Louisa Street, Openshaw - Proposed Highway Works Stage 1 Road Safety Audit

REPORT NUMBER 2023/WH/1867

1.1 This report results from a Stage 1 Road Safety Audit carried out relating to proposals in the way of new internal access roads and priority junction to serve a new residential development off Louisa Street, Openshaw. The audit was carried out during May 2023.

PLAN OF ITEMS RAISED BY THIS AUDIT

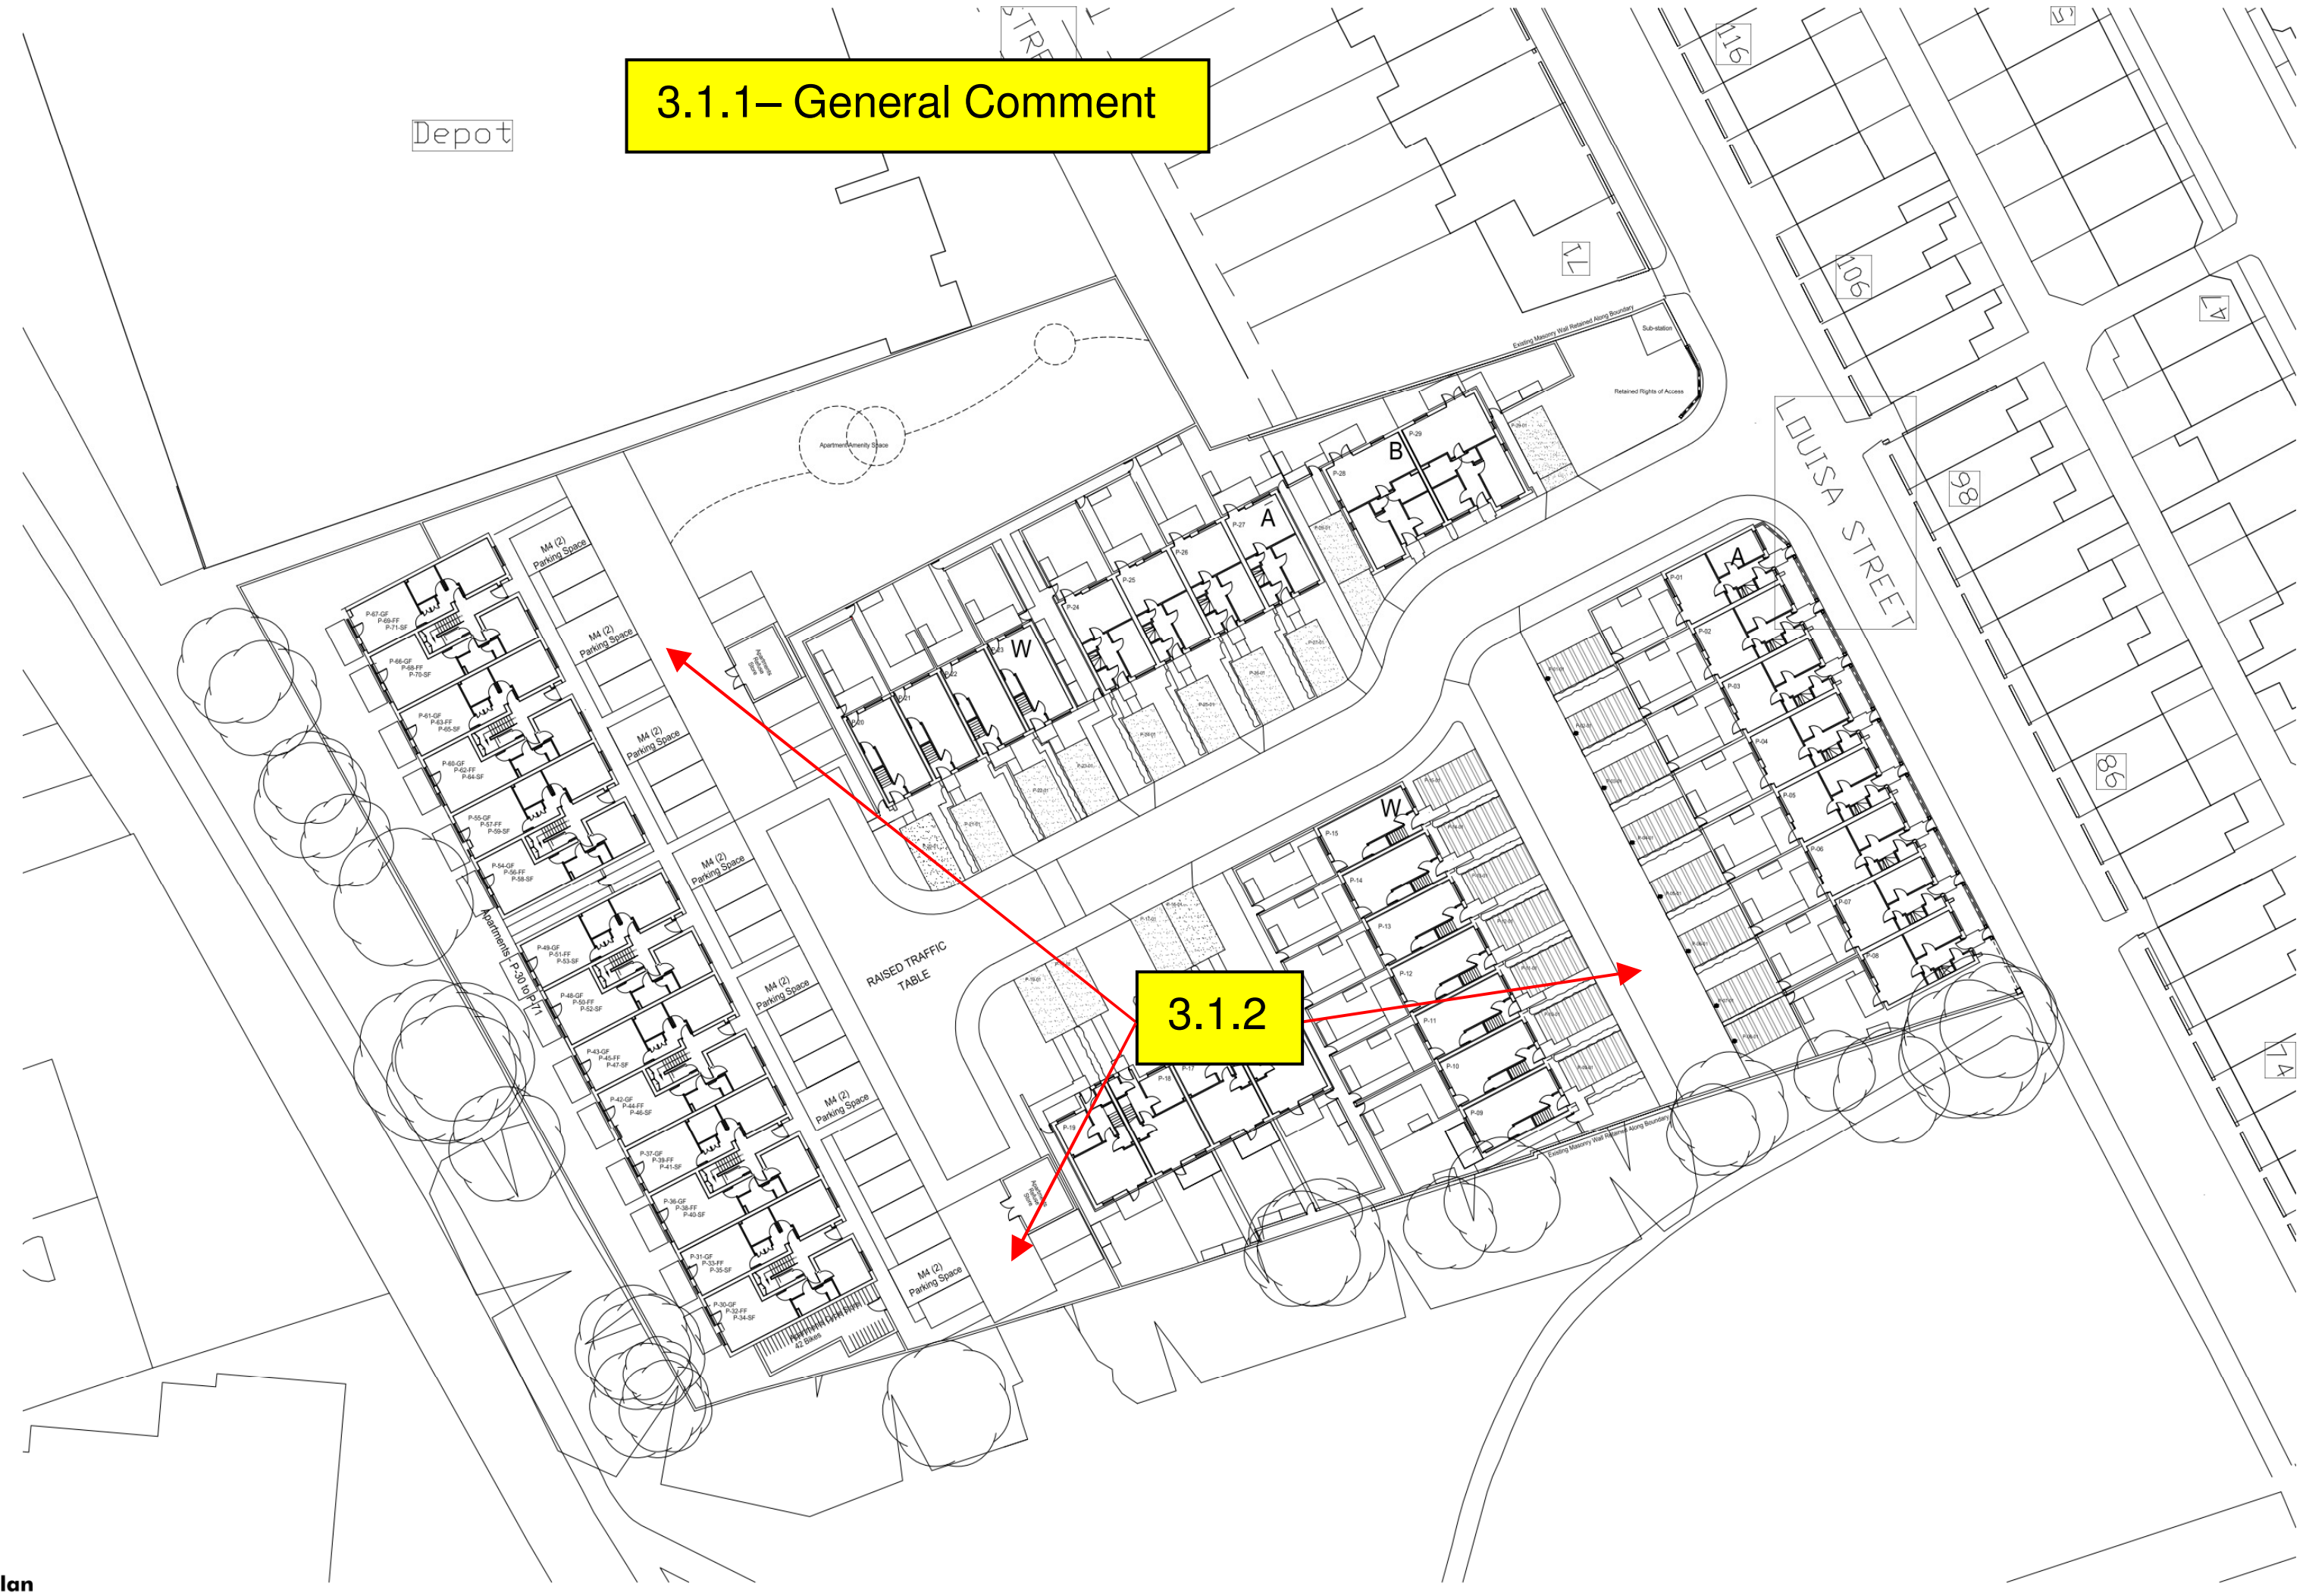
3.1.1 PROBLEM

LOCATION: Proposed junctions, bends and cul-de-sacs

SUMMARY: Insufficient manoeuvring space

It is unclear as to whether large vehicles such as refuse or HGV delivery vehicles can negotiate the proposed junctions, internal bend or cul-de-sac without risk of kerb strikes or footway overrunning which could result in loss of control or conflicts with passing pedestrians.

3.1.2 PROBLEM

LOCATION: Private shared driveways

SUMMARY: Insufficient manoeuvring space

Concern is expressed that delivery vehicles visiting plots accessed via the shared private driveways could be forced to reverse for an excessive distance along or onto the adoptable highway increasing the potential for conflicts with passing vehicles or pedestrians.

RECOMMENDATION

Undertake swept path analysis to determine the exact nature of the problem. If necessary, the geometry should be altered to allow for sufficient manoeuvring space for all type of visiting vehicles.

RECOMMENDATION

Undertake swept path analysis to determine the exact nature of the problem. If necessary, the alignments should be altered to allow suitable turning heads within the private driveways to discourage excessive reversing.
